主旨: RE: [FI] S.16 Planning Application No. A/YL-KTN/1139 - Further

#### 1<sup>st</sup> Further Information

Proposed Temporary Warehouse (Excluding Dangerous Goods Godown) with Ancillary Facilities and Associated Filling of Land for a Period of 3 Years in "Agriculture" Zone,

#### Response-to-Comment (RtC)

#### LANDSCAPE PLAN

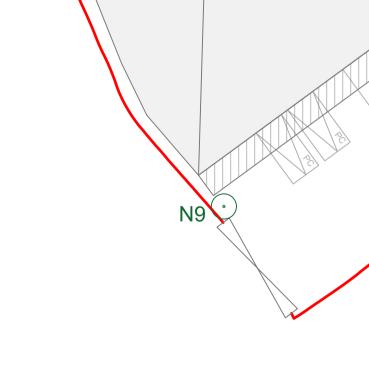
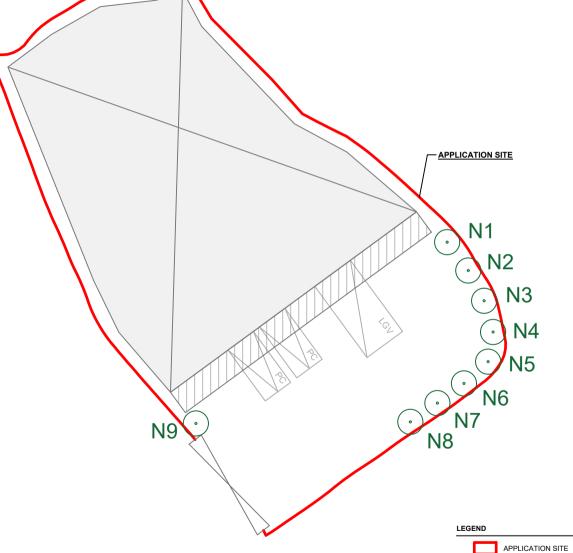
(a)	The Site is partly covered by vegetation. Some	The site inspection conducted on 04.09.2025
	existing trees of common species are observed	identified 10 existing trees of common species at
	within the Site. No tree information, proposed	the application site (the Site). No dead, old or
	tree treatment and mitigation measures(s) has	valuable tree was found therewithin. The tree
	been provided in the application.	survey report is enclosed at Annex 1a.
		All existing trees will be felled as they are in
		conflict with the development scheme. In order
		to mitigate the potential landscape impact that
		would have arisen from the proposed
		development, the applicant proposes to plant 9
		new trees on a 1:1 ratio in terms of numbers,
		with a view to compensating for the 9 existing
		trees to be felled. Given that Leucaena
		leucocephala is an invasive alien species, its
		removal is not to be compensated under the

current scheme. The landscape plan is enclosed
		at Annex 1b.
2.	Comments from the Chief Engineer/Mainland Nort	h, Drainage Services Department (CE/MN, DSD)

**Drainage Proposal**

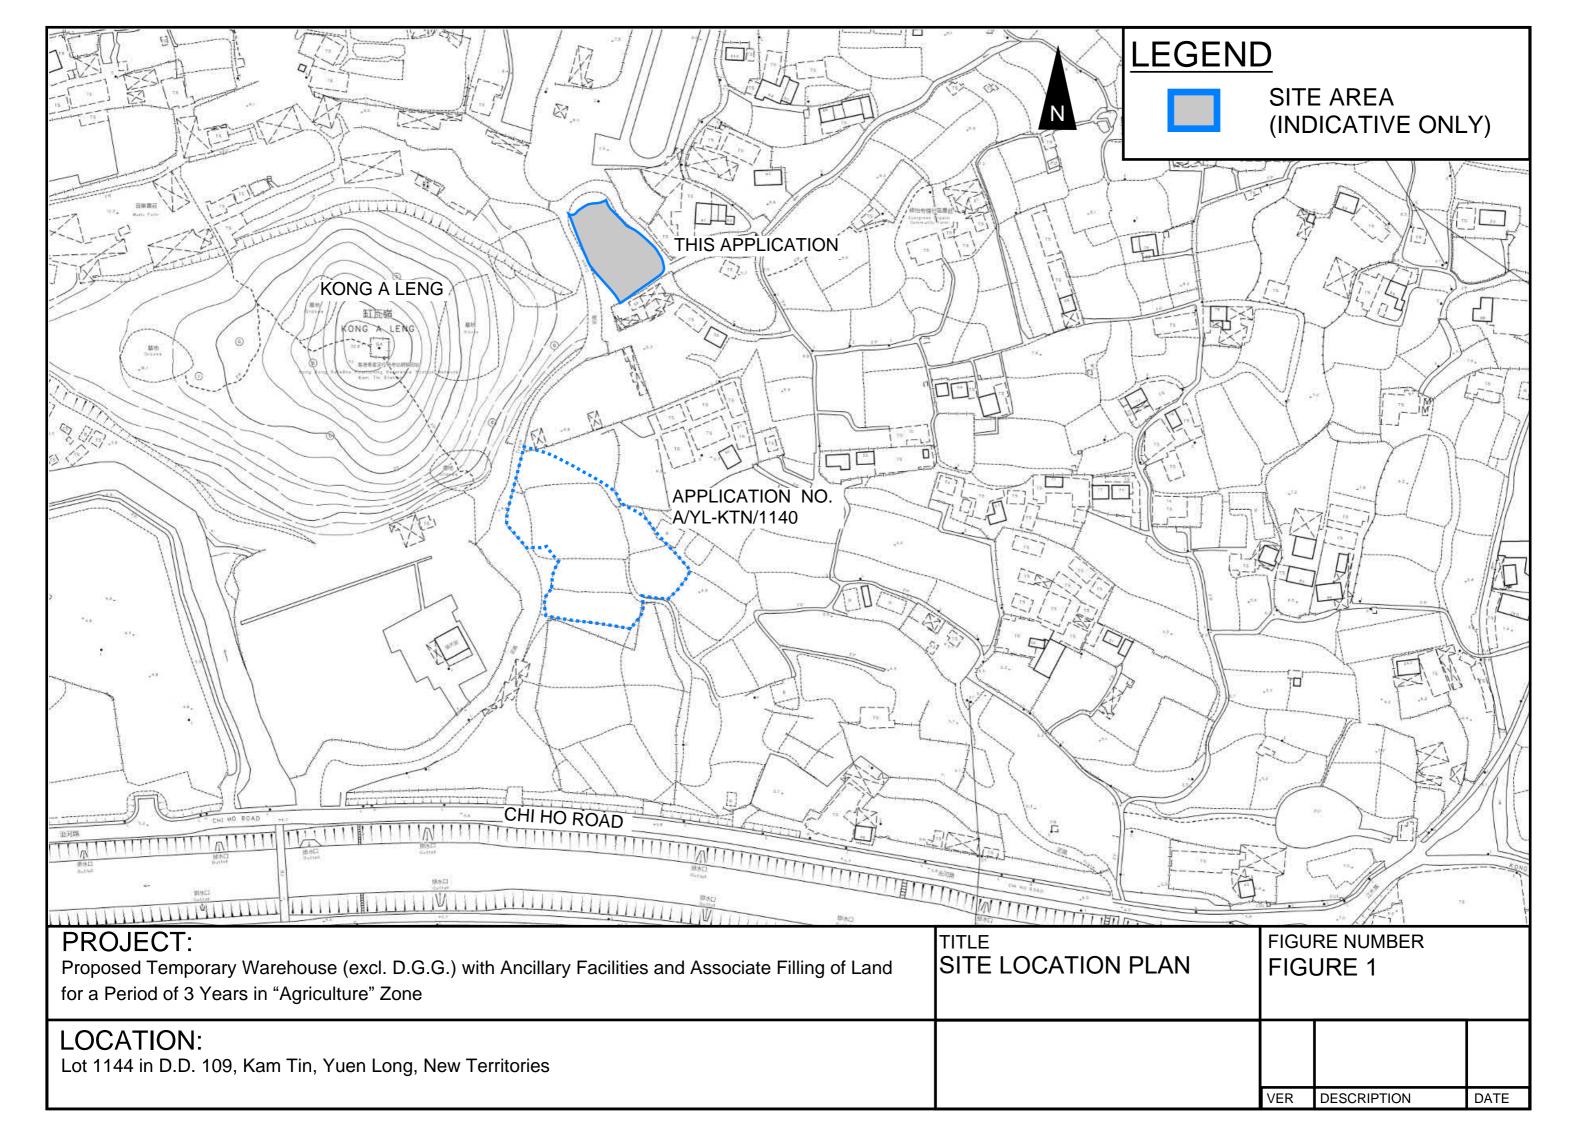
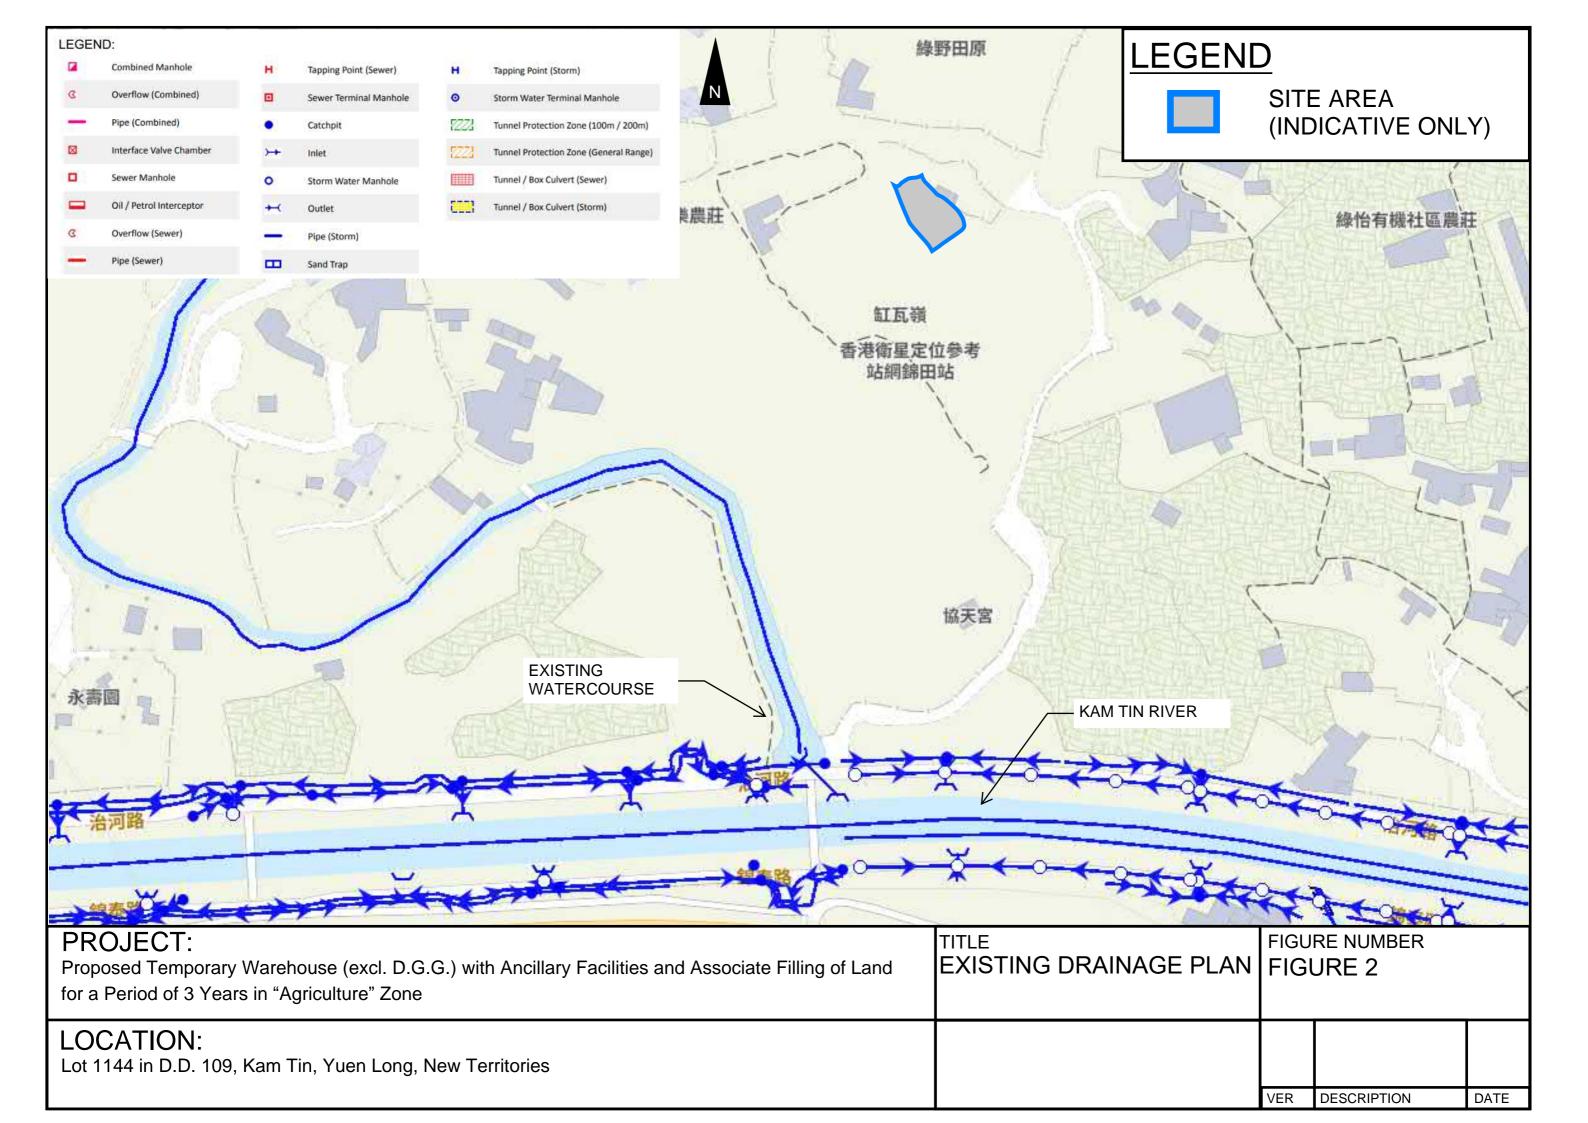
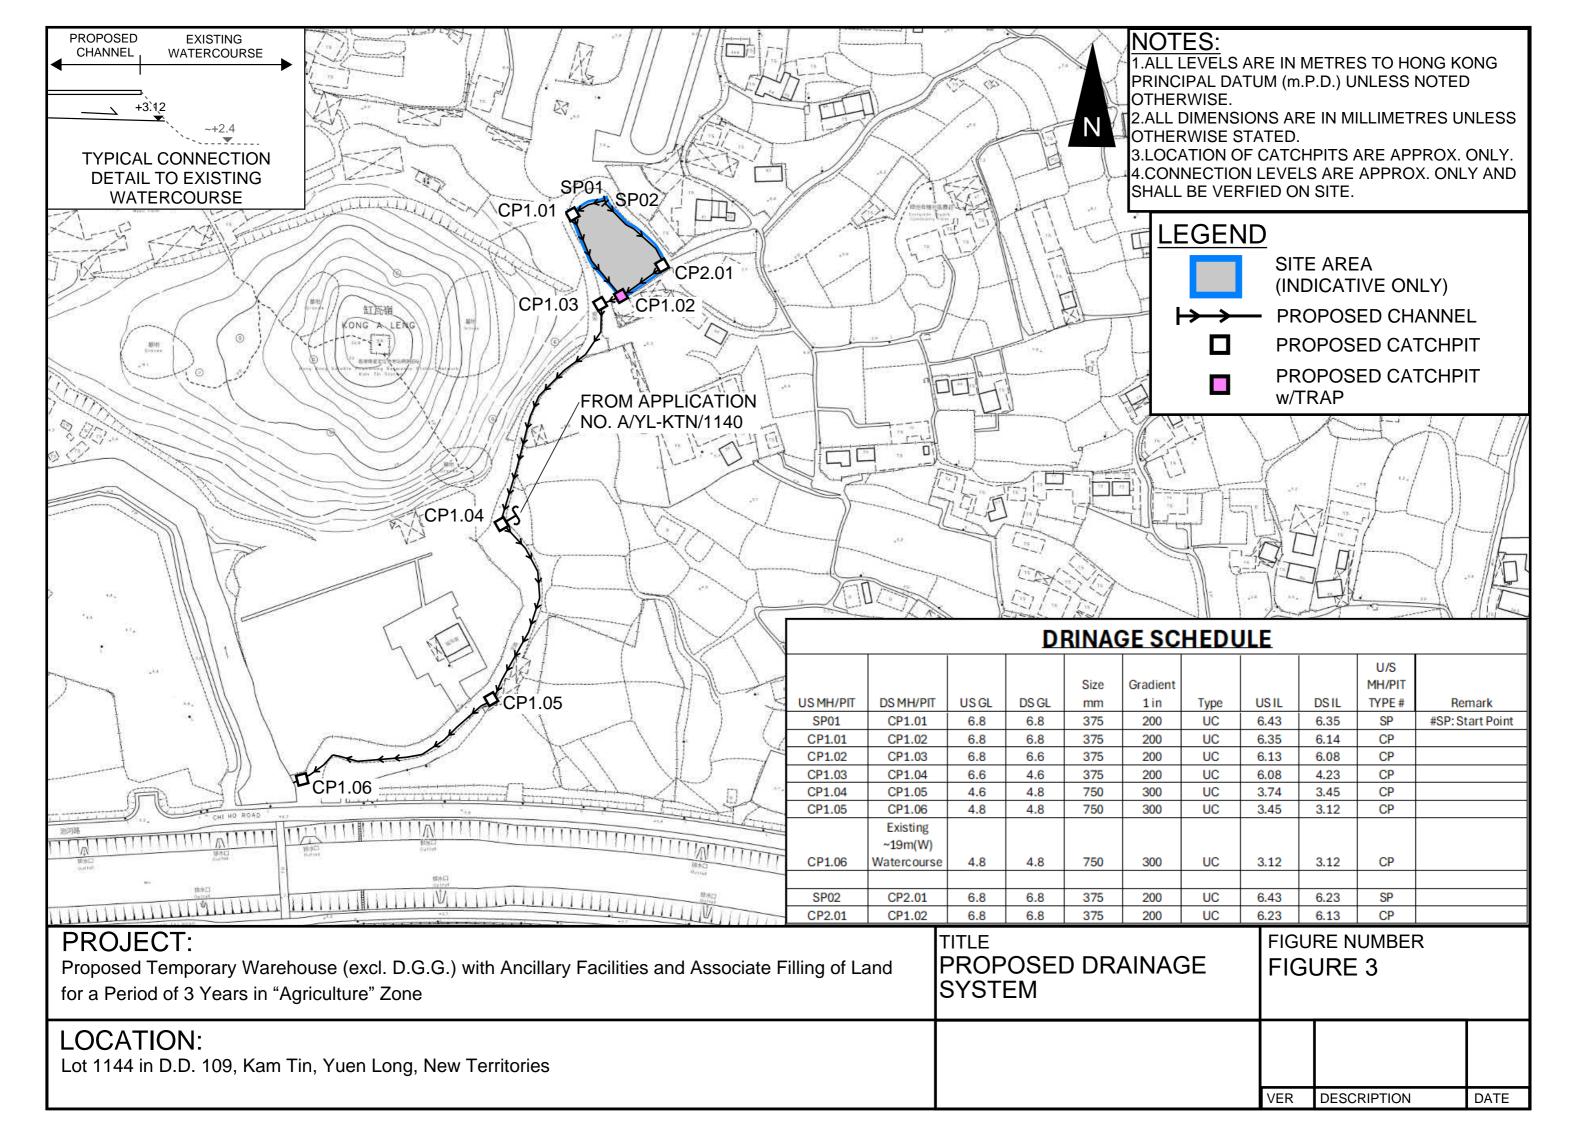
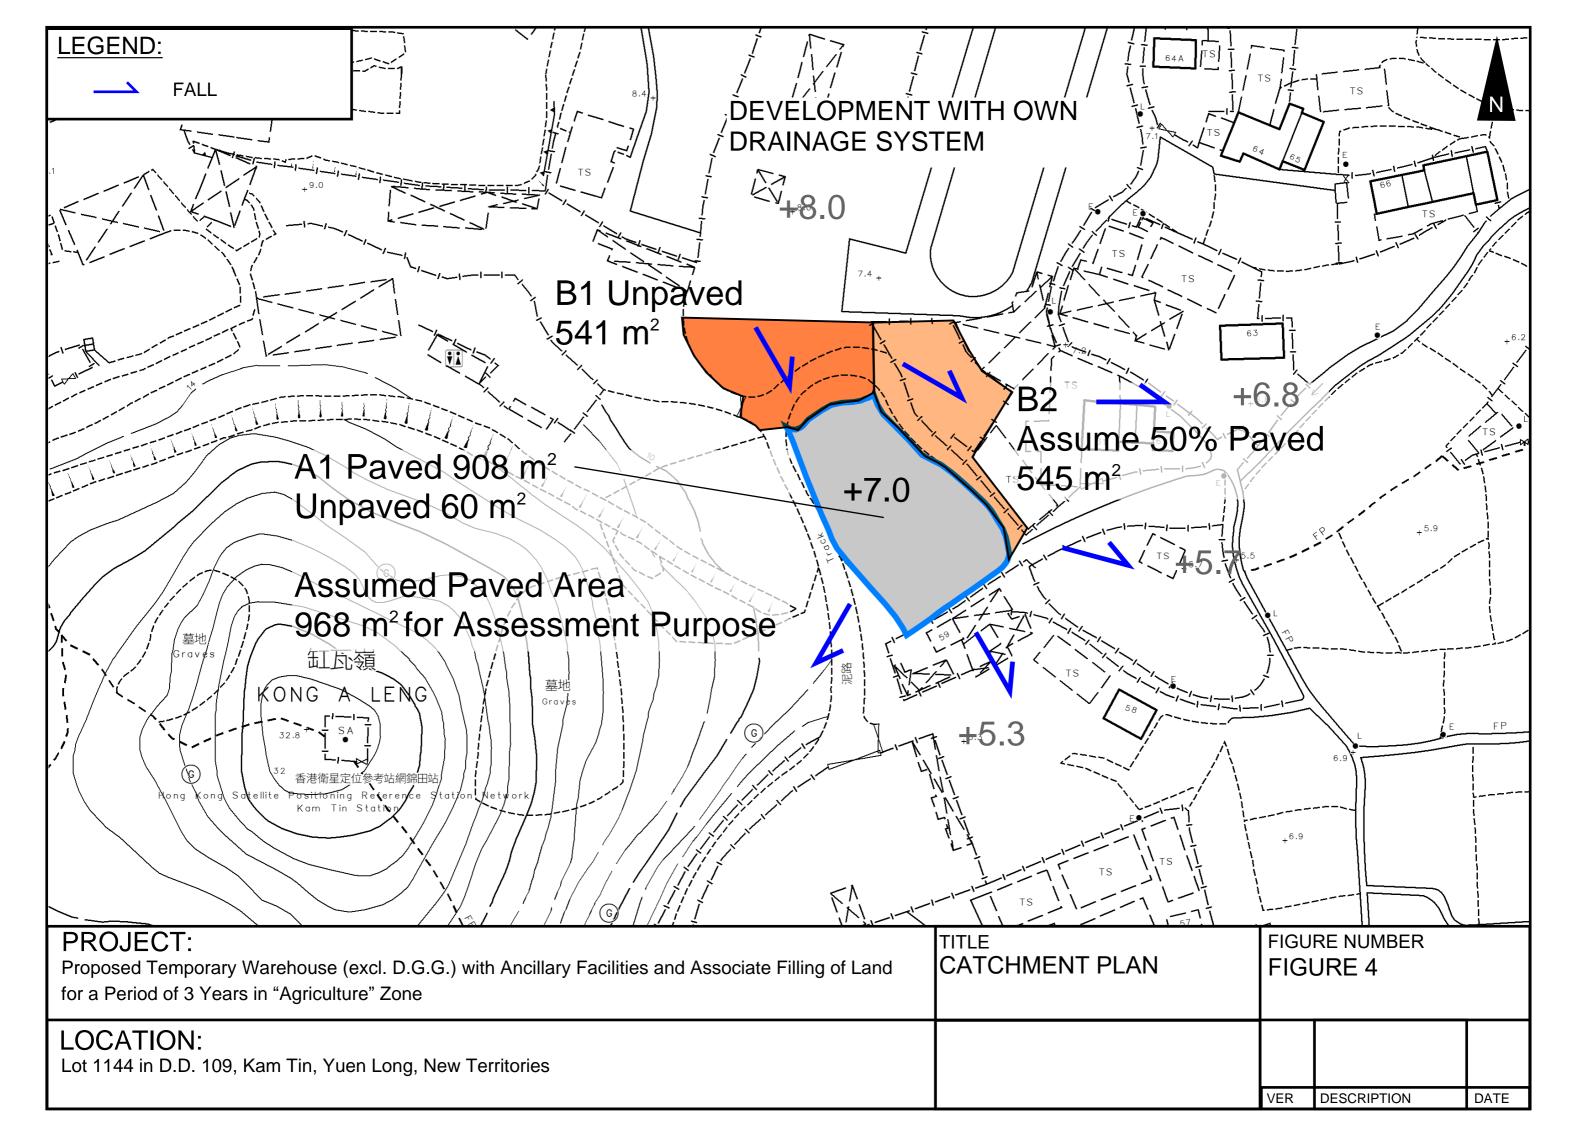
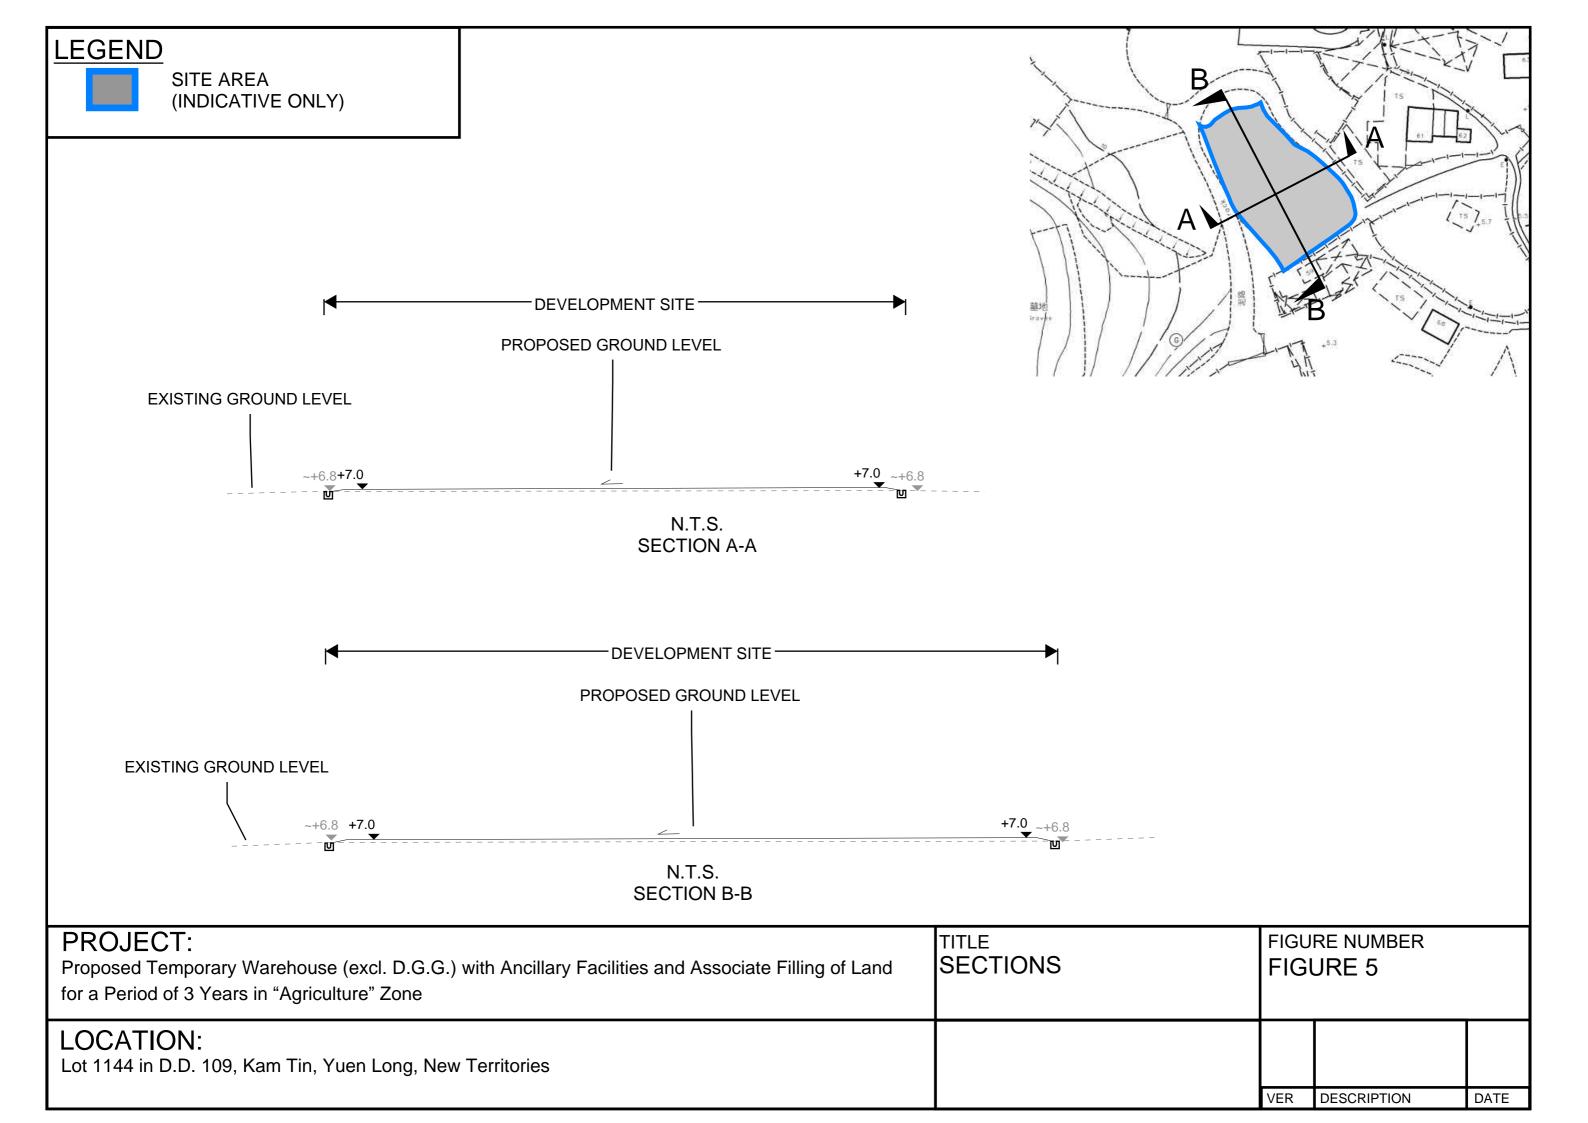
(a)	Land filling work is proposed for the application	The drainage proposal is enclosed at <b>Annex 2</b> .
	site but there is no substantiation to show how	
	the overland flow from adjacent areas would not	
	be interrupted by the proposed works.

- 4.1.1 Proposed channels are designed for collection of runoff for application site. It is proposed to discharge to existing approx. 19m width watercourse which eventually discharge to existing Kam Tin River. According to the checking of existing drains in **Appendix A**, it have enough capacity to carry the flow from existing catchment and proposed development.

- 4.1.2 Proposed channels from CP1.04 to approx. 19m width watercourse are designed to be commonly serve for both this application and application no. A/YL-KTN/1140. The runoff from application no. A/YL-KTN/1140 are also considered.

- 4.1.3 The design calculations of proposed drains are shown in **Appendix A**. Checking of utilization of existing approx. 19m width watercourse is also indicated in **Appendix A**. It is shown that the utilization is only about 0.27%.

- 4.1.4 The alignment, size, gradient and details of the proposed drains are shown in **Figure 3**. The catchment plan is shown in **Figure 4**.
- 4.1.5 Reference Drawings are shown in **Appendix C** for reference.

DWG. TITLE
FILLING OF LAND AREA

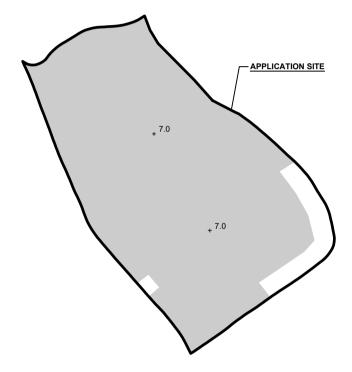
(ii) To echo with the mitigation measures as proposed in the Landscape Plan, the proposed filling of land will be reduced from 968 m² (about) to 908 m² (about) to allow rooms for the tree-planting works. The revised pages of the Supplementary Statement and Form No. S.16-III, as well as the revised plan showing the filling of land are enclosed at **Annex 3**.

COVERED BY STRUCTURE : 585 m² (ABOUT)
PROPOSED FILLING OF LAND AREA : 908 m² (ABOUT)
DEPTH OF LAND FILLING : NOT MORE THAN 0.2 m
